UNITED STATES PATENT AND TRADEMARK OFFICE

APPLICATION NO.	FILING DATE	FIRST NAMED INVENTOR	ATTORNEY DOCKET NO.	CONFIRMATION NO.
10/055,101	01/22/2002	Steven G. Goebel	8540G-000096	9631

Office Action Summary

DETAILED ACTION

Van Dine et al's **Figure 2** below illustrates a schematic representation of a fuel cell power plant showing split passages of the system:

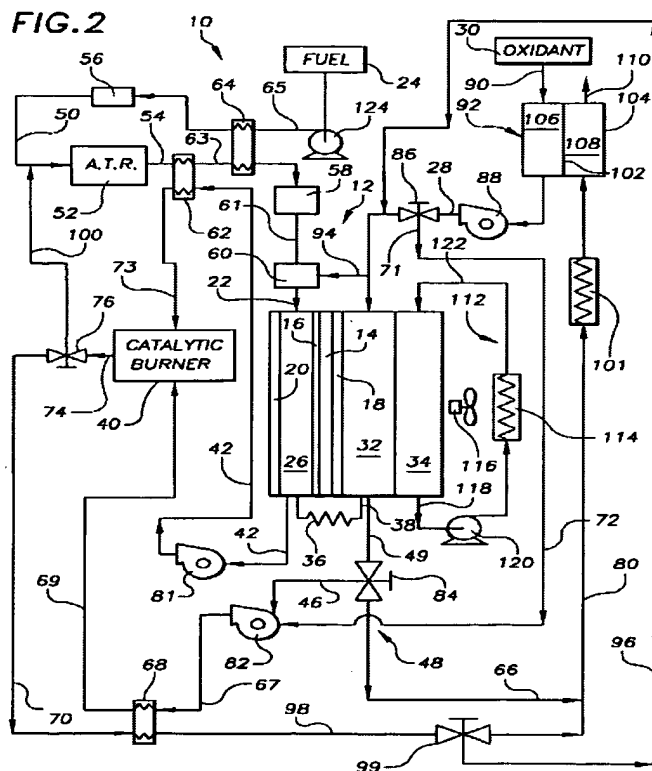
In particular, **Figure 2** depicts a reformer 52 comprising an inlet and outlet; a burner 40 having an inlet and an outlet. The burner inlet is in fluid communication with the fuel processor outlet via extension lines 63 and 61, the anode exhaust passage 42 and extension line 73.

A recirculation loop including a valve 76 for selectively providing fluid communication between the fuel processor inlet and at least the combustor outlet is also illustrated.

A bypass passage providing fluid communication between the recirculation loop and the combustor inlet is illustrated by the passage including extensions 70 and 98, the diversion line 96, the exhaust passage 49, and the extension 69.

Any of valve 99, valve 86 or valve 84 selectively provides fluid communication between the recirculation loop and the combustor inlet.

Van Dine et al teach that all extension passages and their respective valve are operable to set a recirculation ratio (COL 14, lines 34 to Col 15, line 15).

Any of valve 74, valve 99, valve 86 or valve 84 is able to control fluid communication in the recirculation loop.

Fluid compression means 81 and 82 are in fluid communication with the recirculation loop.

FIG.1

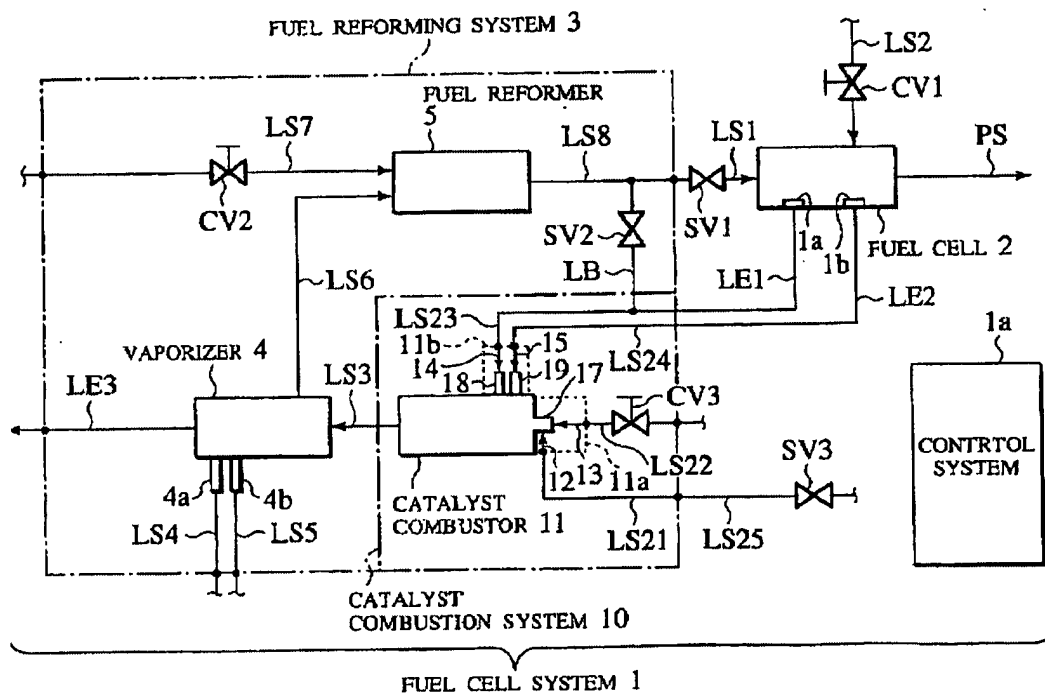
Kobayashi in **Figure 1** below depicts a block diagram of a fuel cell system including a reforming system 5 having a combustion system 11 wherein the combustor inlet is in fluid communication with the reformer outlet via the reformed fuel supply line LS1 and the reformed fuel bypass line LB that has shutoff valves SV1 and SV2 and ; the combustor supply line LS3 is also in fluid communication with the reformer inlet. Valves SV1 and SV2 selectively provides fluid communication between the recirculation loop and the combustor inlet, and they are both operable together for setting the required fluid flow therein (SECTIONS 0023-0032).

FIG. 1

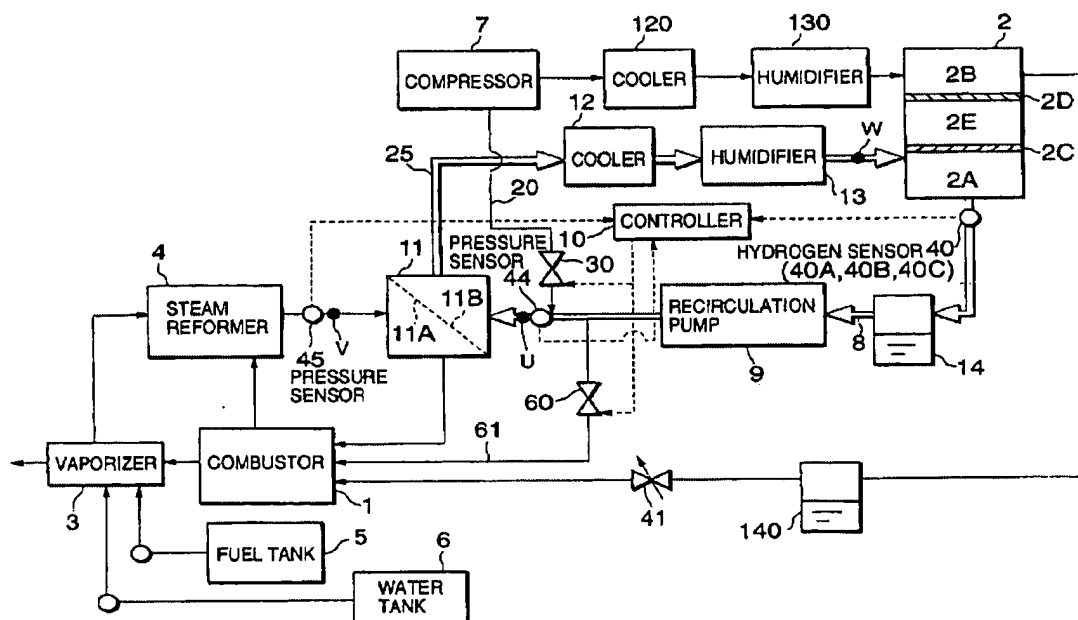
Ilo et al teach a reformer 4 and a combustor 1 wherein both the reformer and the combustor include inlet and outlet. It is disclosed that the combustor 1 generates heat by reacting gas containing hydrogen supplied from the anode effluent recirculation passage 8 through a discharge valve 60 and reformat gas generated by the steam reformer 4 with oxygen contained in the cathode effluent supplied through the pressure control valve 41 (SECTION 0028). As shown in **Figure 1** below, the recirculation loop includes a valve selectively providing fluid communication between the reformer inlet and the fuel processor outlet and the combustor outlet. The fuel processing system further includes a recirculation pump 9 in fluid communication therewith.

FIG. 1

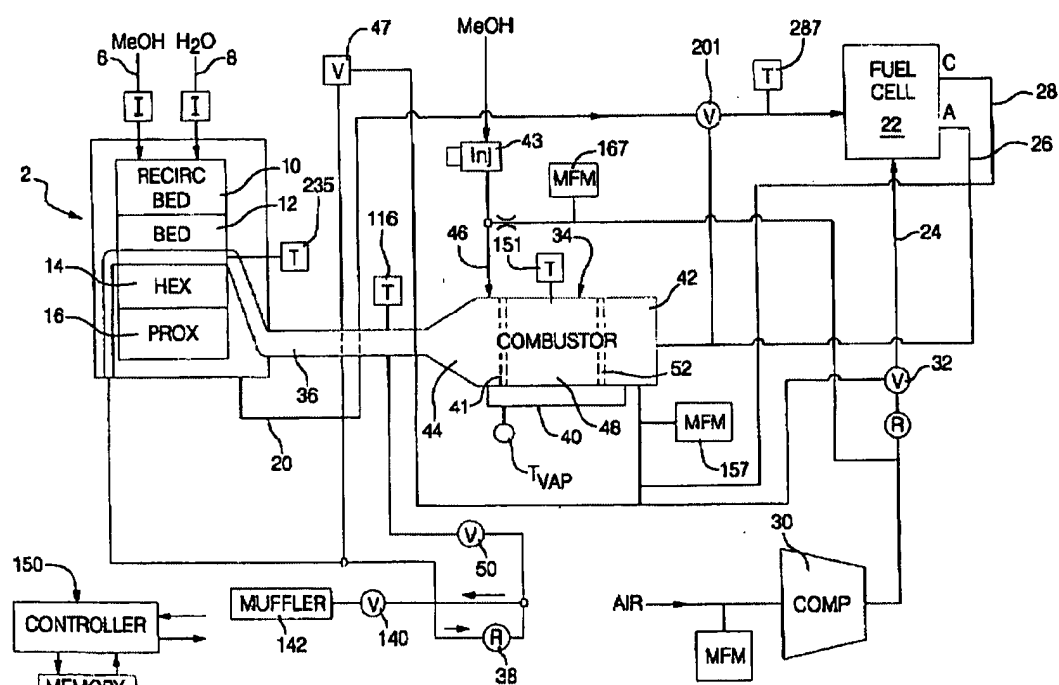
Hart-Predmore et al disclose a fuel processing apparatus comprising a fuel processor 2 and combustor 34, both of them including respective inlets and outlets; wherein the entire output of the fuel processor 2 is recirculated to the combustor 34 as fuel through a fuel bypass valve 201 which supplies the fuel processor output gas stream to a second inlet on the combustor 34 (COL 11, lines 45-65).

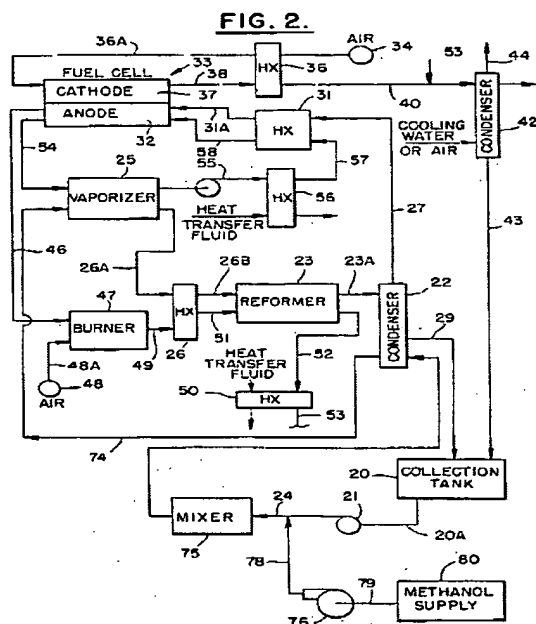
Beshty et al illustrate in **Figure 2** below gas stream exiting reformer 23 passing through line 23A and into condenser 22 where the gas stream is cooled to a lower temperature within a preferred working temperature to condense much of its water content by heat exchange with the as yet unreformed water/methanol feedstock being circulated therethrough (COL 6, lines 20-28).

In view of the above, it would have been obvious to one skilled in the art at the time the invention was to use the condenser in fluid communication with the fuel processor outlet of Beshty et al in any of the fuel processor of either Van Dine et al'366 or Kobayashi'141 or Ilo et al'024 or Hart-Predmore et al'561 because Beshty et al teach that the gas stream exiting reformer is feed into the condenser where the gas stream is cooled to a lower temperature within a preferred working temperature to condense much of its water content by heat exchange with the as yet unreformed water/methanol feedstock being circulated therethrough. Thus, the condenser is employed to condense water of gas stream.
